City of Ottawa
Building Code Services
October 7, 2024
Grading Reviewed
Jamil Akila
Reviewer Name

Telephone # 723-9227
Plan # 4M-1593
Project name: DIAMONDVIEW
Civic Address: 108 CHANDELLE PRIV.
House model: ROWAN 'M'

LOT 77 SITE/GRADING PLAN
DIAMONDVIEW PHASE 3

INDIVIDUAL LOT GRADING REVIEW SUMMARY FOR SITED HOUSE AS COMPARED WITH OVERALL SUBDIVISION PLAN

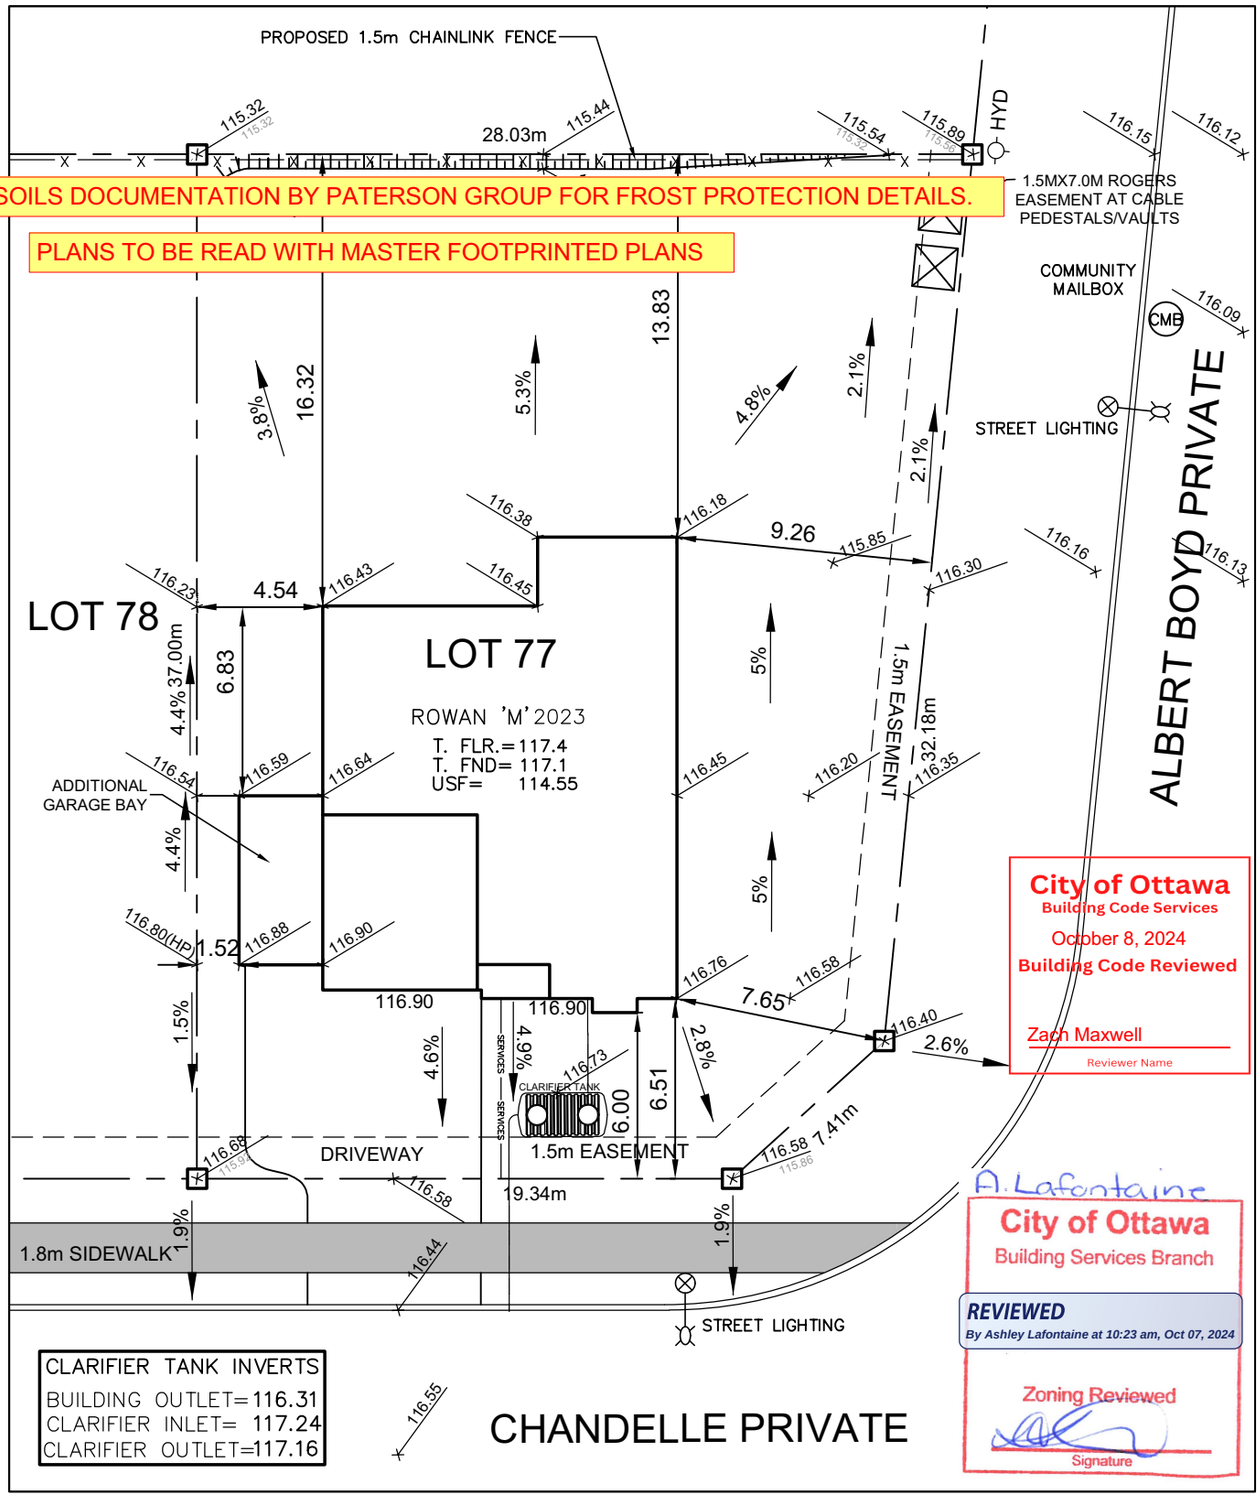
Grading Review Approval is only for attached garage bay

Top of Foundation to be min. 0.15m above final grade

USF to have min. 1.5m cover around foundation or foundation shall be insulated

Existing grading and drainage patterns must not be altered

No excess drainage to be directed towards adjacent properties

Roof runoff to be directed toward Right-of-Way unless otherwise approved. Splash pad to be provided if downspout within 1.5m of property line

Match existing elevations with abutting properties
